Tree Removal and Tree Pruning Application

Application no: *DA2018/0152*

Arboricultural Comments
21 Woorarra Avenue
North Narrabeen

Project No 5042/A
February 2016

Plan by MCK Architects, Cashman House, First Floor Plan Dwg DA 05/Rev. A, Dated 14/10/15

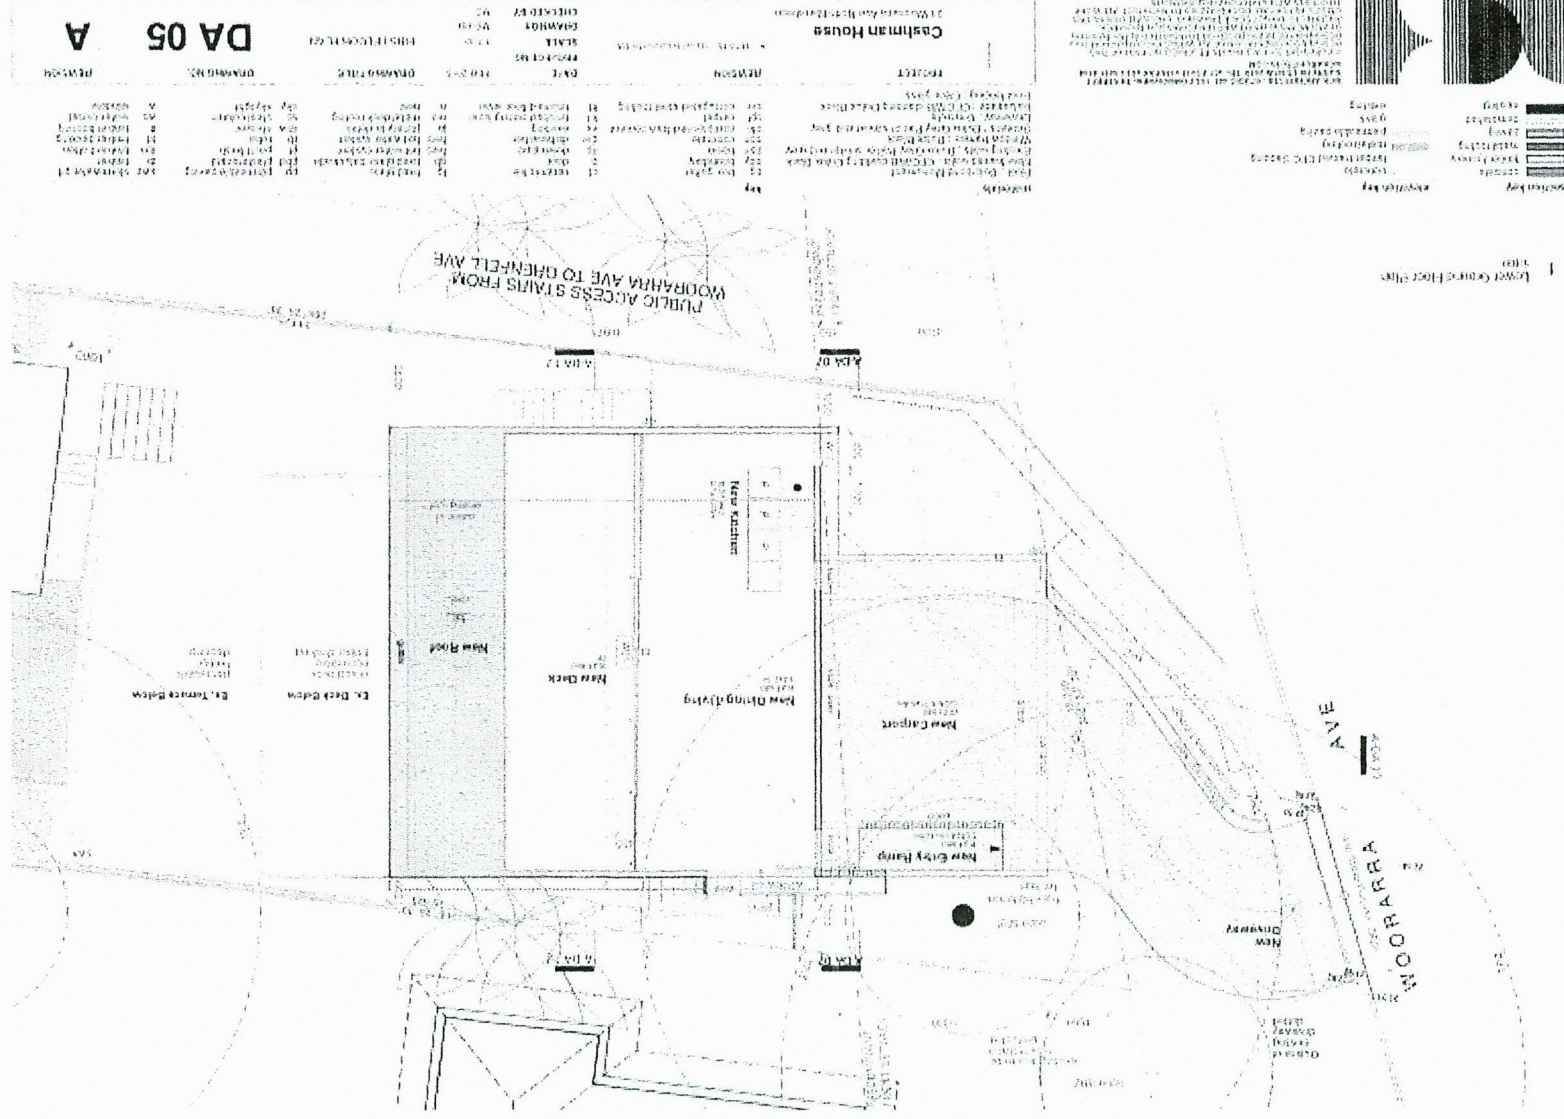
Plan DA05 indicates entry ramp, which appears to be from the new decking, and I assume has no footings into the soil.

Plan by ITM Design, Job 14/205/A /Rev.? Dated to be supplied

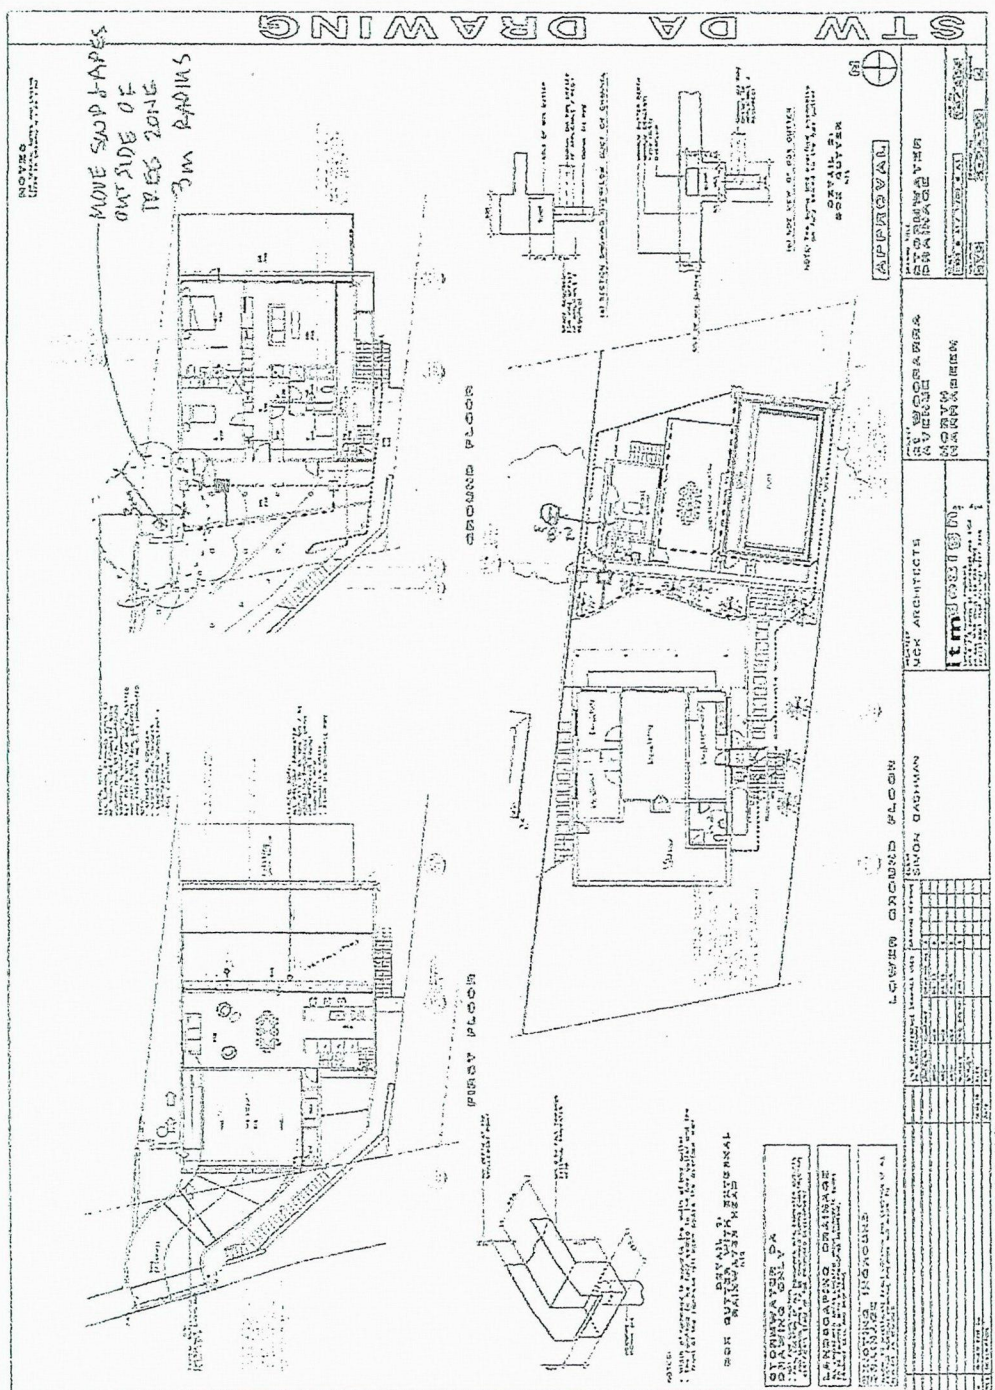
I am advised that drainage is to be relocated to outside the SRZ See sketch plan of hydraulics. (Current plans indicate inappropriate location of SWP within the SRZ).
